**ITEMS RECEIVED AFTER THE PRODUCTION OF THE REPORT**  
**FOR THE PLANNING COMMITTEE**  
**TO BE HELD ON 30 NOVEMBER, 2023**

<b>Application No.:</b> 2023/00337/FUL	<b>Case Officer:</b> Mr William Groom
<b>Location:</b> 7, Sycamore Close, Llandough, Penarth	
<b>Proposal:</b> Proposed two storey extension to rear elevation with hipped roof

Planning Application: 2023/00337/FUL

7, Sycamore Close, Llandough, Penarth

PROPOSED REAR ELEVATION

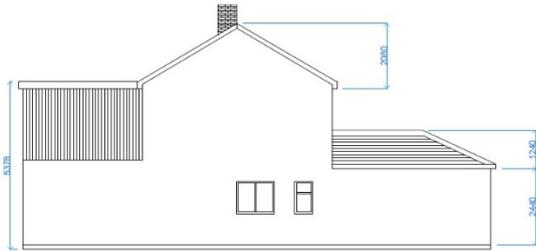
Both the supporting letter from **Asbri Planning** and the report produced by the **planning officer** for the Planning Department have not dealt with **overshadowing** using data. Computer modelling is the only accurate way of predicting the **overshadowing** produced by the extension **with** hipped roof. There are a number of variables to be considered in this prediction, e.g. topography of the location, the constantly changing Sun's path and elevation daily above the horizon during different seasons, 'strength' and angle of the Sun's rays etc.. The diagram included here (using the scale diagram provided by the planning agent) will support my assertion that the *hipped roof apex height must be* reduced below the **6.8m** quoted, in order to 'reduce the overall visual massing' and so reduce the effects of the overshadowing. This is shown in RED on the diagram below. **There is absolutely no reason why the hipped roof is required to be so high!**

The Committee report fully considers the overshadowing impacts on neighbouring occupiers and in summary concludes that the degree of overshadowing impacts would not be so harmful to warrant refusal of the application.

PROPOSED LEFT SIDE ELEVATION

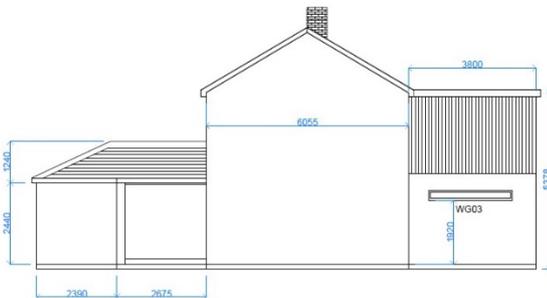
**[Two windows already installed and NOT approved]**

The two windows are on the **north-facing wall**. These are located on what would be the *least* energy efficient direction and the most likely to **detrimentally impact the privacy of No 6 Sycamore Close**.

Members should note that the insertion of the new ground floor windows on an existing dwellinghouse is considered to constitute permitted development. As set out in the Committee report, the smaller window provides views towards the blank side elevation of 6 Sycamore Close and has no unacceptable overlooking impact towards this neighbour. The larger window serves the kitchen / dining area of the extension which provides views towards the shared boundary with 6 Sycamore Close, however due to the existing boundary treatment between the application site and this neighbour, it is not considered to provide any views that would detrimentally impact upon the privacy of this neighbour.

PROPOSED RIGHT SIDE ELEVATION

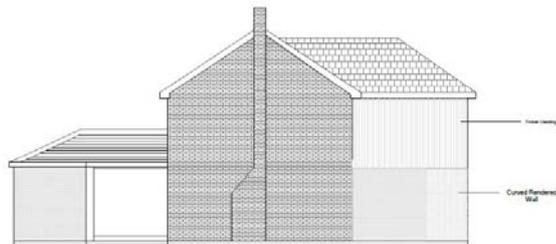
**[NO]**

The **south-facing wall** has NO windows which is not the most efficient use of the building's orientation to maximise the heating affect of the Sun's rays and illuminate the interior of the ground floor! This is a very poor design if planning experts do not use this **eco-friendly approach** to reduce the energy required to heat the home. Why not place the TWO additional windows on this side and so reduce the impact on the privacy of No. 6 Sycamore Close.

In respect of the placement of windows, with regards to maximising energy efficiency and solar gain, there are no national or local planning policies or guidance which would require an applicant to place windows in particular elevations to achieve / maximise more solar gain. The matter of energy efficiency would currently fall under Building Regulations.
